Access Compliance Report

Public Rights-of-Way

(Pedestrian Signals)

Intersection ID: N/A	Main Street:	Cross Street: N/A	Location: N/A
ADA ID: 61301DEC5915	Signal Type: One Push Button-Non APS	Overall Compliance: No	Severity Score: BTN 1: N/A BTN 2: N/A No BTN: N/A
Codes/Mitigation Info/Possible Solution		Field Measurements/Component Compliance

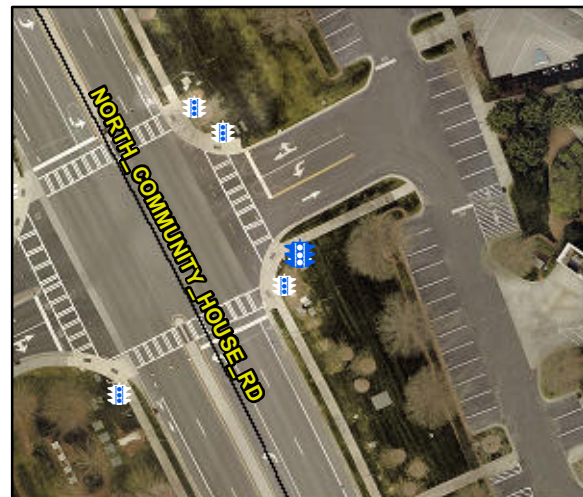
Yes	B 1 Clear Xing Direction?	ClearlyMarked	N/A	B 2 Clear Xing Direction?	N/A
	B 1 Crossing Direction	To NW		B 2 Crossing Direction	N/A
Yes	B 1 DistanceTo XWalk (in)	0.0	N/A	B 2 DistanceTo XWalk (in)	N/A
No	B 1 DistanceTo Curb (in)	98.0	N/A	B 2 DistanceTo Curb (in)	N/A
Yes	B 1 Diameter (in)	2.0	N/A	B 2 Diameter (in)	N/A

Possible Solutions: Replace Signal Push Button With APS Button on New Post. Remove & Relocate Sign.
